# Statement

**Product Name:** BT&WIFI Module

**Model Number:** FC66E&FC66E-B

**FC66E-B: FCC ID:** XMR2023FC66EB

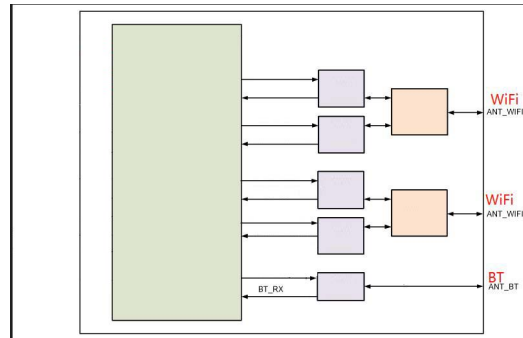
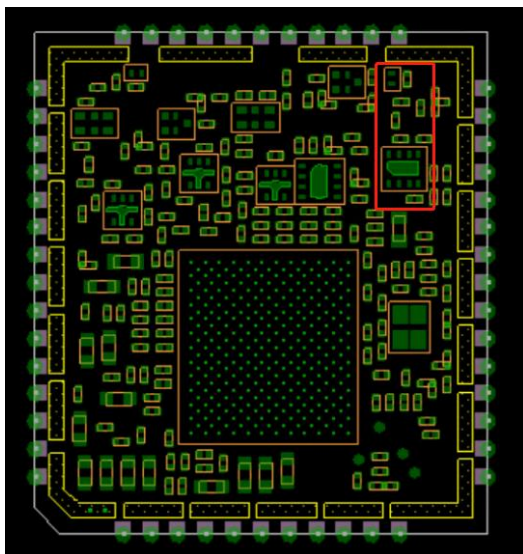
1. FC66E version is BT/WiFi0 shared antenna, FC66E-B version is BT individual antenna

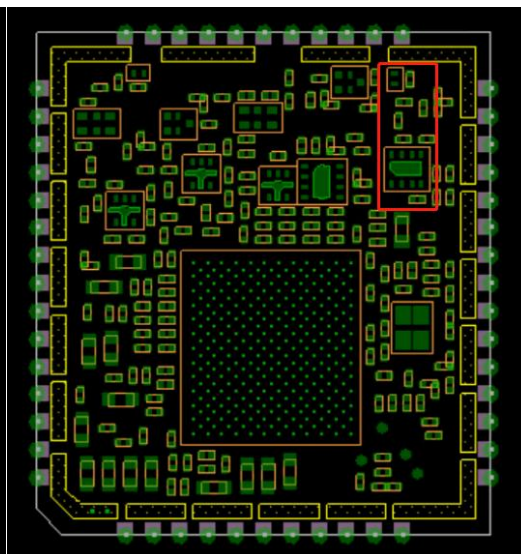
2. The part in the red box are mounted in the FC66E-B version.

We hereby state that there is no any other internal difference between them and the change are mounted part of Bluetooth individual antenna which won't affect the WiFi RF portions
